**NORTH SALT LAKE PLANNING COMMISSION  
NOTICE & AGENDA  
April 13, 2021  
6:30 p.m.**

**TO:** Planning Commission  
**FROM:** Mackenzie Bennett, Planner  
**DATE:** April 13, 2021  
**SUBJECT:** Site Plan for Wasatch Container Addition, 645 North 400 West

**TO:** Planning Commission  
**FROM:** Mackenzie Bennett, Planner  
**DATE:** April 13, 2021  
**SUBJECT:** Site Plan for Cyprus Credit Union, 450 East 1100 North

**TO:** Planning Commission  
**FROM:** Sherrie Pace, Community Development Director  
**DATE:** April 13, 2021  
**SUBJECT:** Love Carpet Cleaning 580 North Main Street

**C-101**

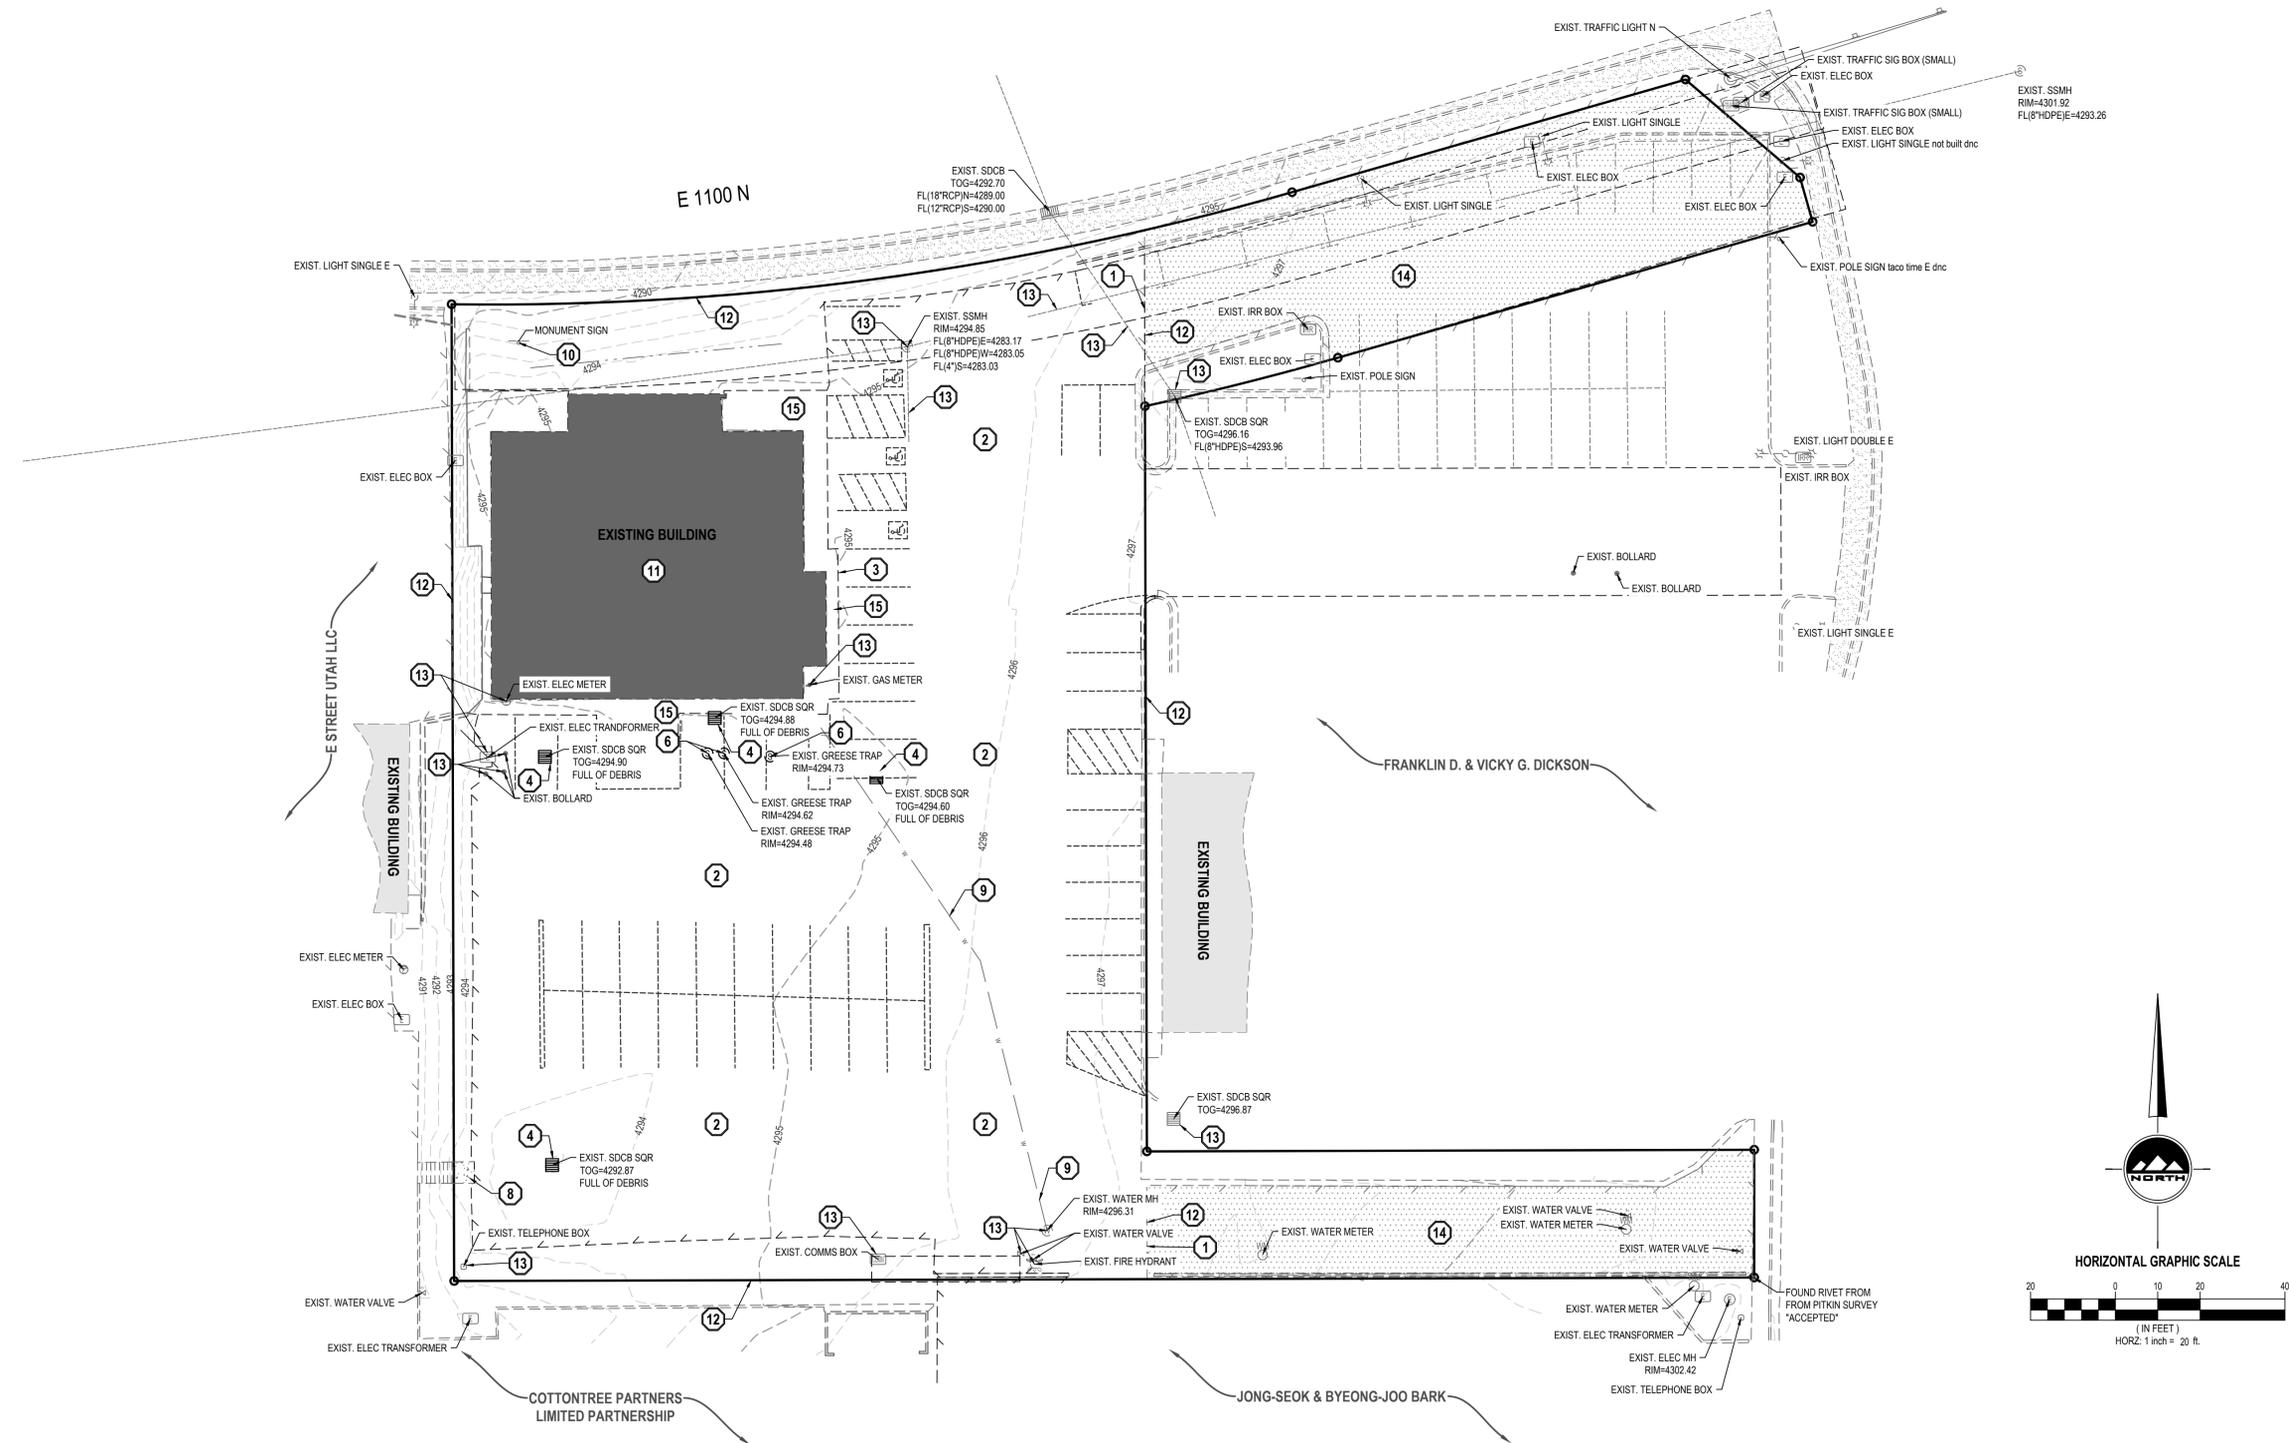
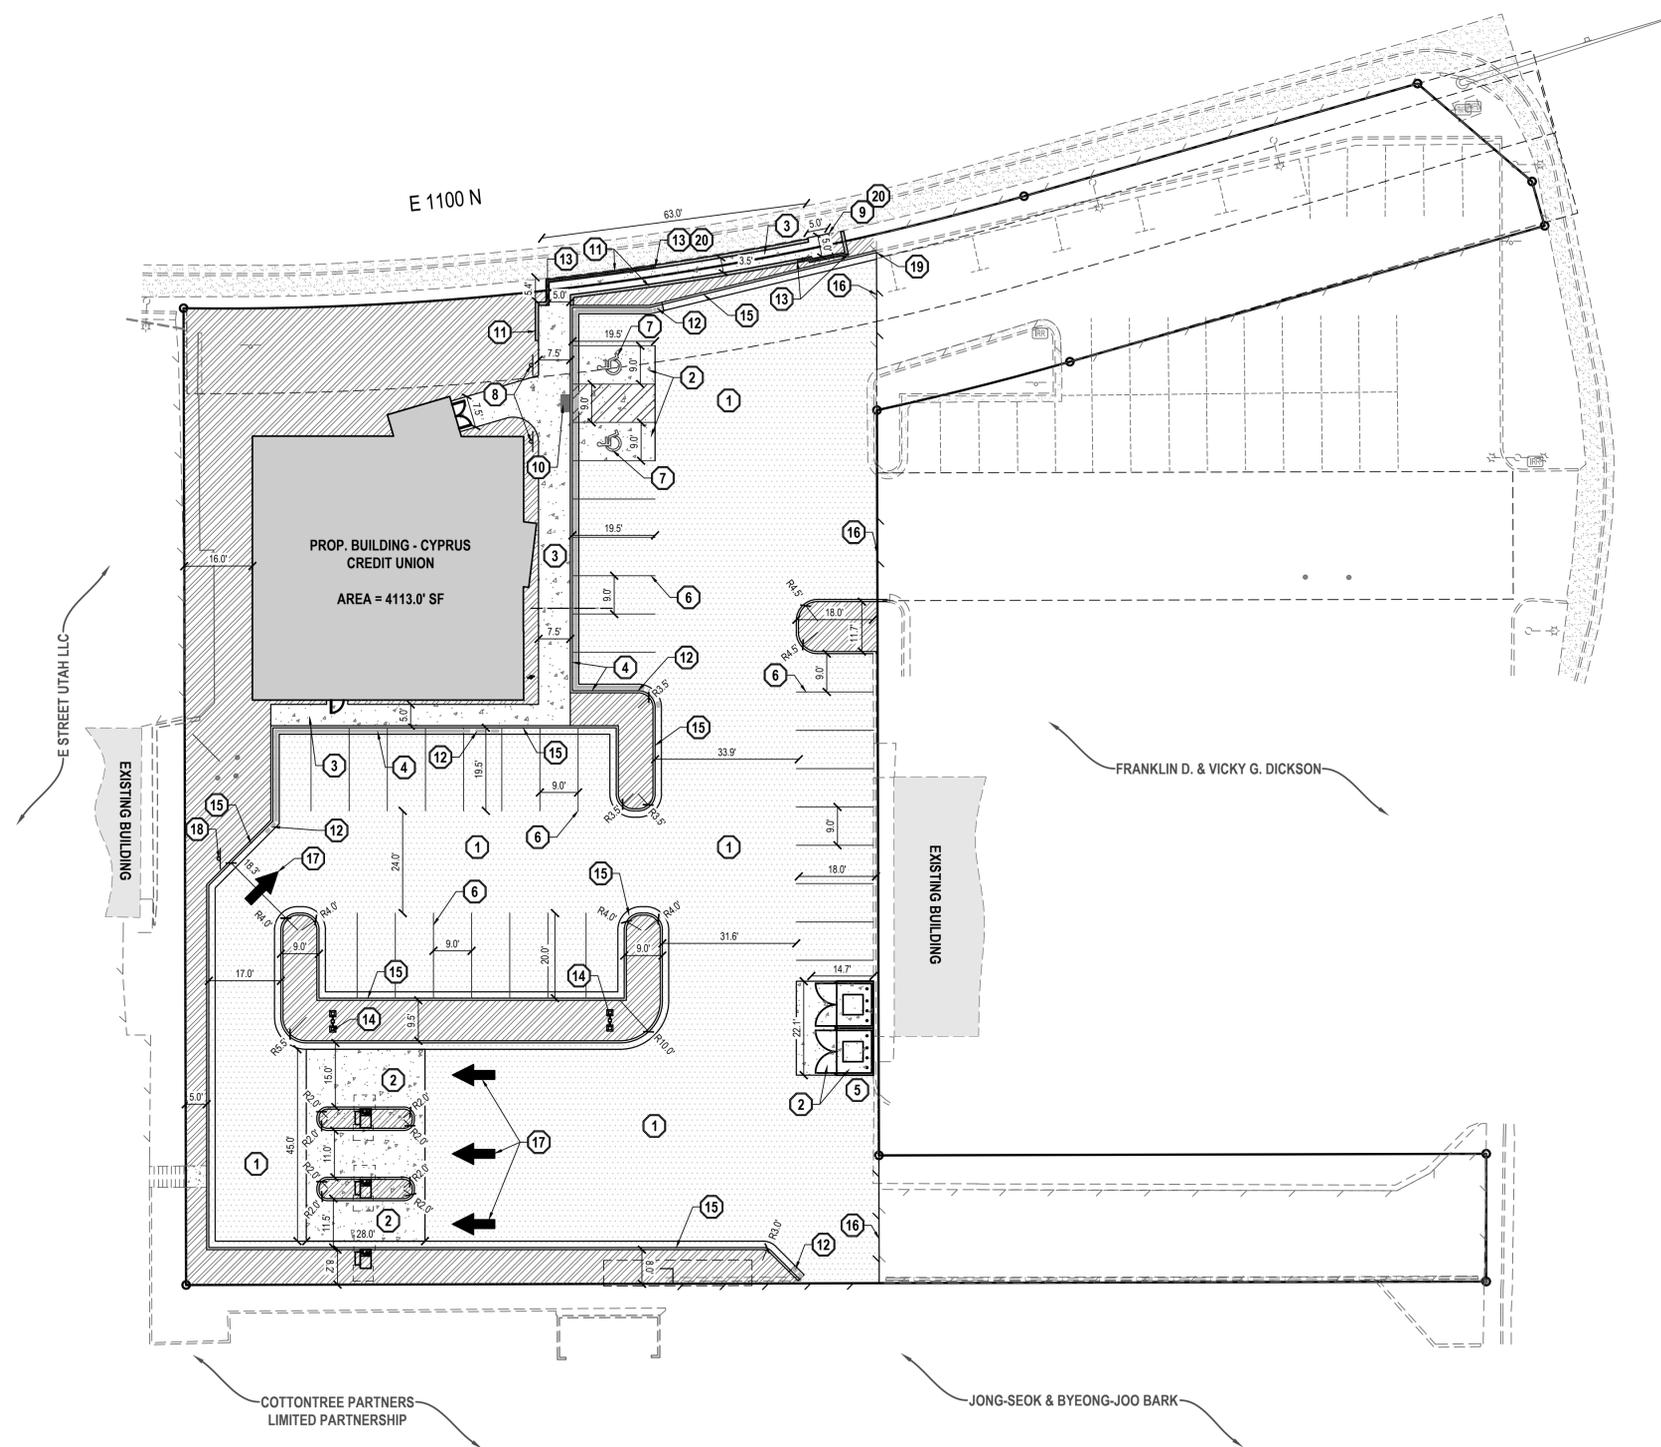
1. Obtain approval from UDOT to construct a sidewalk and retaining wall within their right-of-way;
2. Provide a letter, prior to final occupancy, from a licensed surveyor certifying that the storm drain system has been constructed to the design elevations and that the overall system will operate as designed;
3. Engineering redlines, if any.
